## SERVICE ACTION

<b>Reference number:</b>	SA-18-0252	<b>Issued:</b> 19 February 2016
<b>Subject:</b>	Modification to the Electrical Connections on the V12 Starter Solenoid	
<b>Model(s):</b>	Vanquish (13 MY onwards), DB9, Rapide S, V12 Vantage, Vantage GT12.	
<b>VIN range:</b>	Refer to the VIN list published on the DCS Portal	
<b>Applicable to:</b>	All Dealers	
<b>Distribute to:</b>	After Sales Manager Executive Manager Service Manager Sales Manager	Warranty Technician(s) Parts

Figure 1

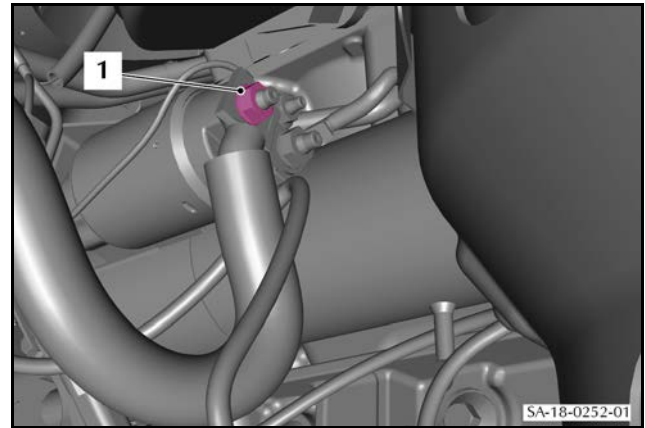
5. Remove the nut (1) that attaches the battery supply cable to the starter solenoid (solenoid) (refer to Figure 1).

7. Examine the terminal on the battery cable. If necessary, clean the terminal.
8. Examine the stud on the solenoid. If necessary, clean the stud.
9. Put the battery cable back into position on the stud of the solenoid.
10. Install and tighten a new nut that attaches the cable to the stud of the solenoid.

Figure 2

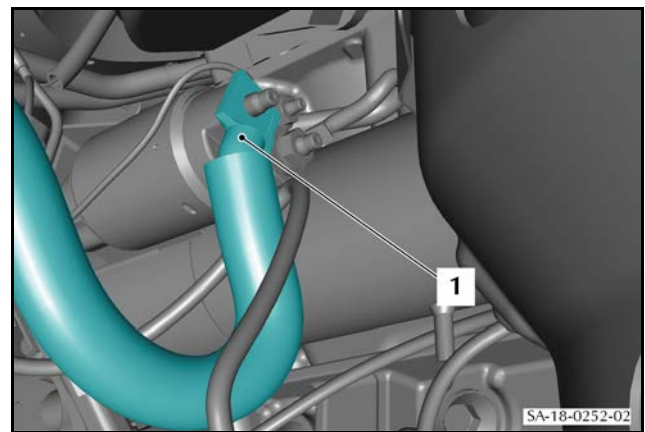
6. Remove the battery cable (1) from the stud on the solenoid (refer to Figure 2).

Figure 3

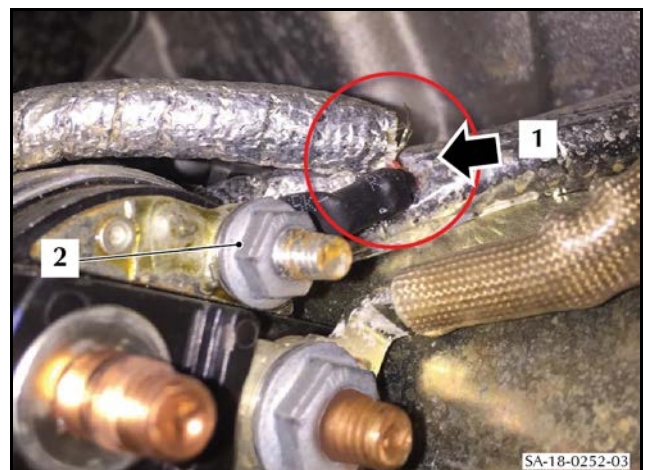
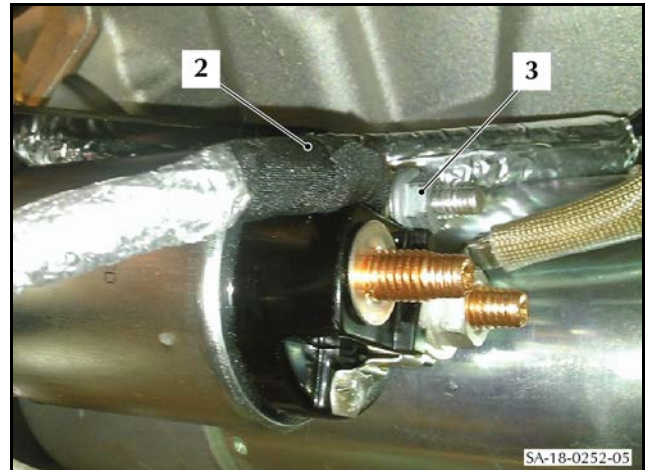
11. Examine the position and condition of signal wire to the solenoid.
12. If the wire is at an acute angle (1) (refer to Figure 3), failure of the wire insulation can occur.

13. If the angle is too acute, remove the nut (2).
14. Remove the wire from the stud and examine the insulation.
15. Wind self-amalgamating harness tape around the wire from the terminal for approximately 4 cm (2) (refer to Figure 4).

16. Put the wire onto the stud with the routing shown in Figure 4.
17. Install and tighten the nut (3).
